<b>Location:</b>	<b>533 Kirkham Street</b> <b>(See map on reverse)</b>
<b>Assessor's Parcel Numbers:</b>	<b>004-0069-002-01 &amp; -002-02</b>
<b>Proposal:</b>	Design Review discussion for a proposal to construct an eight-story mixed use building containing 289 dwelling units and approximately 2900 square feet of ground floor commercial. The proposal involves a State Density Bonus proposal that would include 13 units designated as very-low income.
<b>Applicant:</b>	Justin Zucker / Rueben, Junius & Rose LLP
<b>Owners:</b>	TC II 533 LLC
<b>Planning Permits Required:</b>	Regular Design Review for new construction, Minor Conditional Use Permit for driveway location, and Major Conditional Use Permit for a development project in excess of 100,000 square feet in the S-15 Zone.
<b>General Plan:</b>	Community Commercial
<b>Zoning:</b>	S-15(W)
<b>Environmental Determination:</b>	Determination Pending
<b>Historic Status:</b>	Not a historic property

**SUMMARY**

# CITY OF OAKLAND PLANNING COMMISSION

Case File: PLN22173  
Applicant: Kyle Winkler/Tidewater  
Address: 533 Kirkham St  
Zone: S-15

### Bay Window Projections

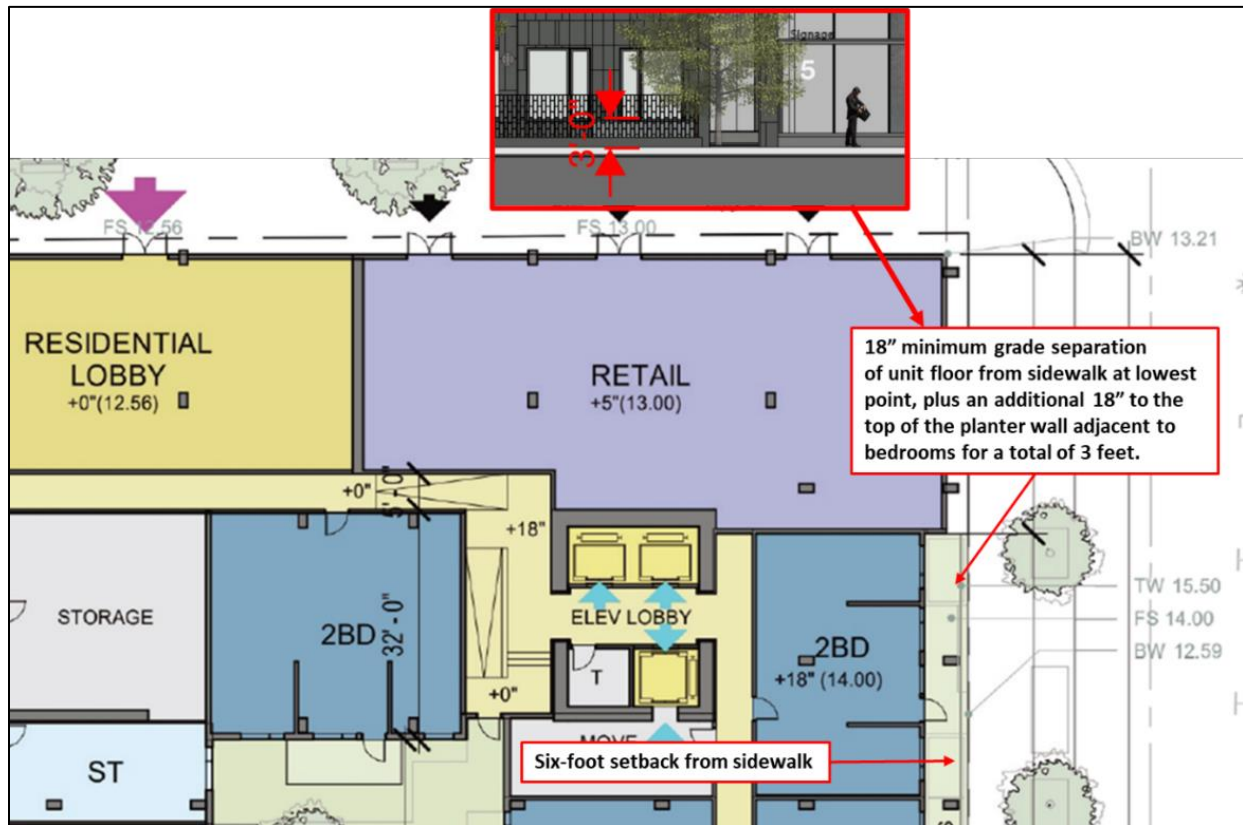
The WOSP Design Guidelines includes guideline Neighborhood Commercial 2: Massing, which states, *“Residential upper stories are encouraged to include bay windows above the ground floor to provide light and air, and to break up the scale of buildings and convey residential use”*. The proposed project does not include any bay window projections as encouraged by this objective guideline and is therefore not consistent. However, any bay window projections would be required to extend into the public right of way and would require a Major Encroachment Permit processed by OakDOT and subject to approval by the City Council. Due to a number of past projects incorporating projections into the right of way that were deemed excessive, OakDOT had taken the position of putting a hold on supporting any further requests for such projections until a set of standards is established that clearly sets the parameters as to what level of dimensional projections into the right of way would be acceptable. Currently, OakDOT is investigating whether bay projections consistent with limitations specified in the California Building Code may be allowable and is reviewing bay projections on a case-by-case basis. However, given the direction from OakDOT at the time the development application was being considered under the pre-application, the design was developed without recommendation from Planning to include bay window projections into the design. Staff feels that it would be inappropriate to require the development project to incorporate bay projections at this time given that the architectural design concept has been established and the inclusion of bay windows would not work well with the current design. Furthermore, the guideline in question states that bay projections at upper stories are “encouraged” and not necessarily required, and the proposed recess on the 7<sup>th</sup> Street frontage that includes balconies provides the break in massing and residential feel of the building as intended by this guideline.
